Colorado Department of Transportation

Staff Bridge Branch

RAIL ANCHOR SLAB/BEAM RAIL/CURB DRAIN DETAILS			
Designer:	XXXXXXXX	Structure Numbers	XXXXXXXXXXXXXX
Detailer:	XXXXXXXX		XXXXXXXXXXXXXX
Sheet Subset:	WALL	Subset Sheets:	WXX of XXX

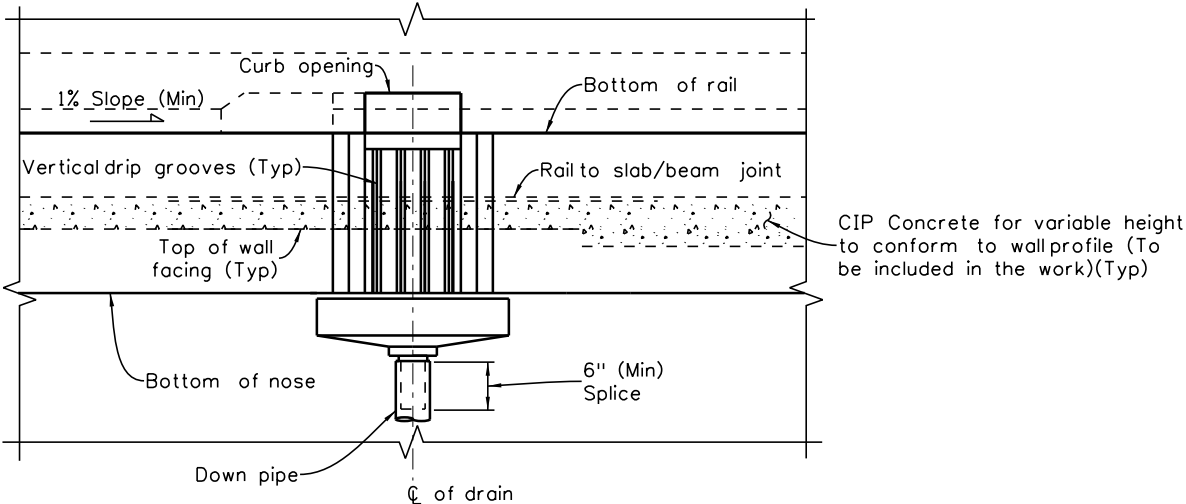
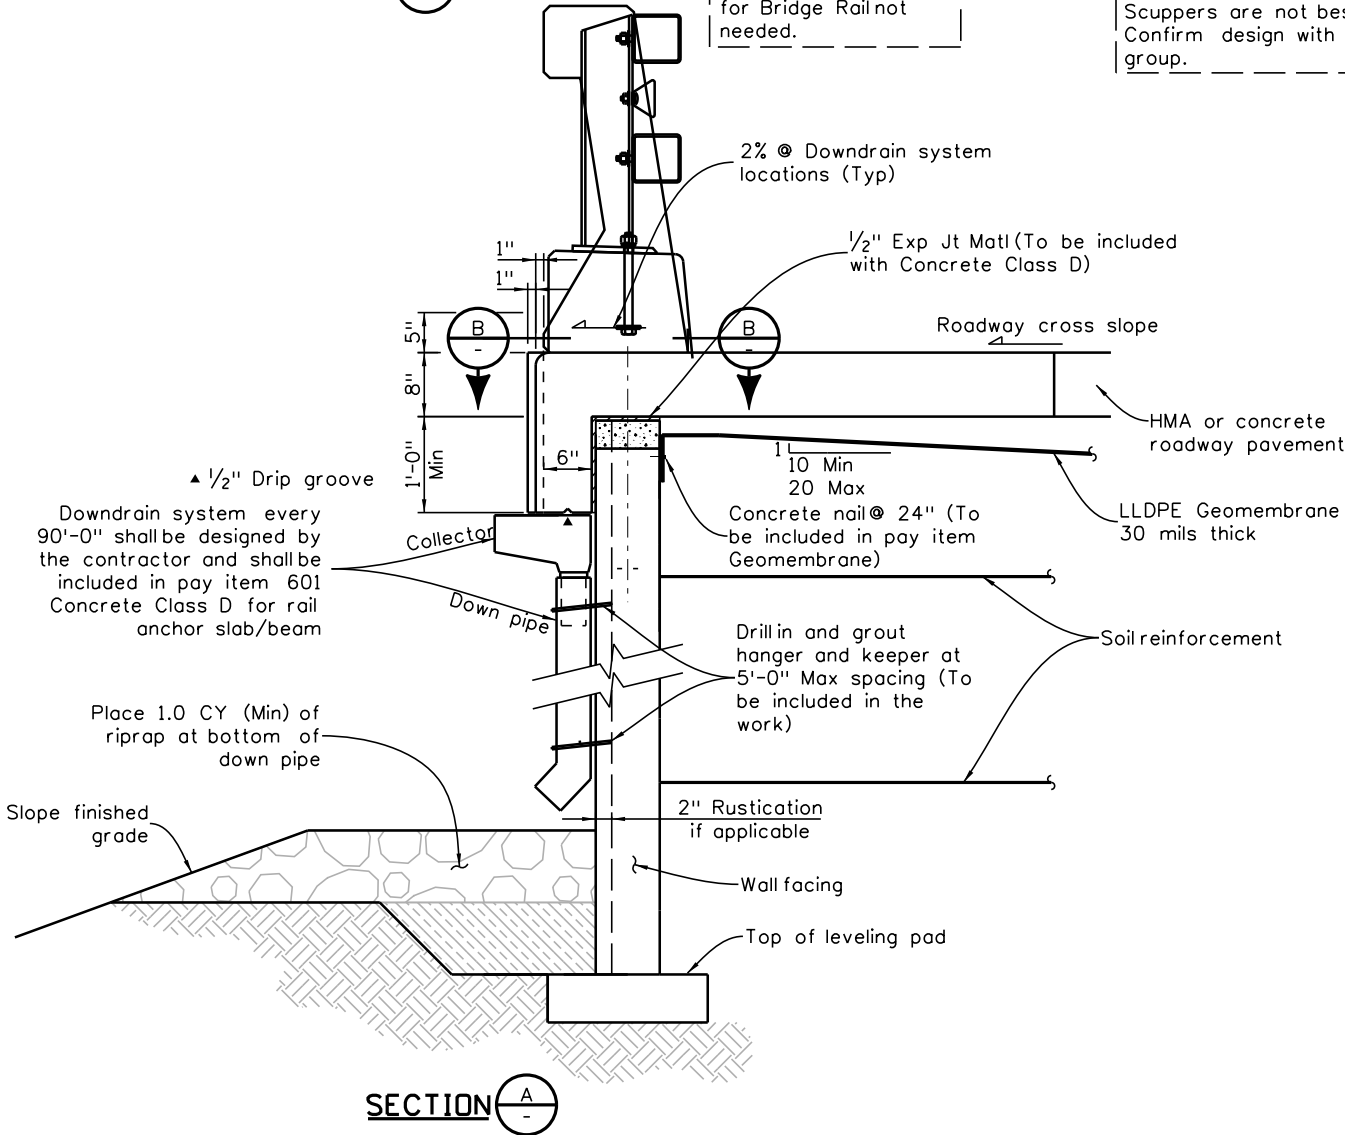
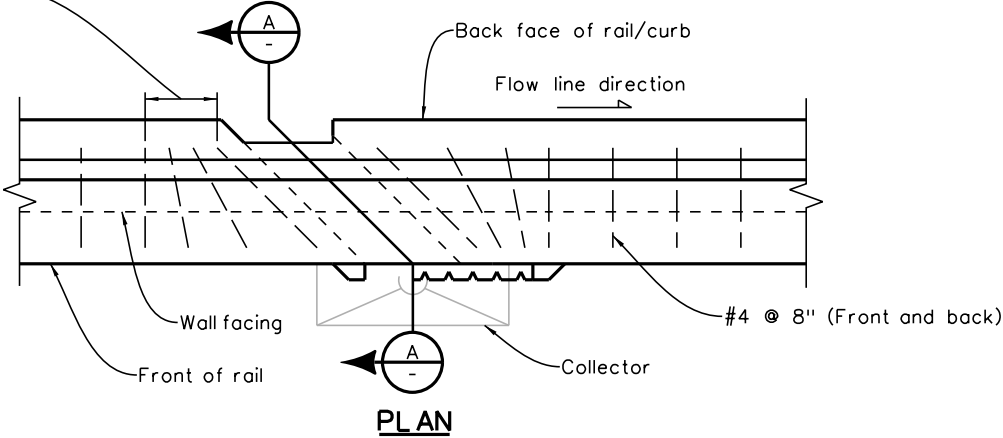
Detailer: Turn off level for Bridge Rail not needed.

Note to Detailer/Designer: Scuppers are not best option. Confirm design with Hydraulics group.

#4 @ 3": Fan the last 3 pairs of bars (Typ) per side
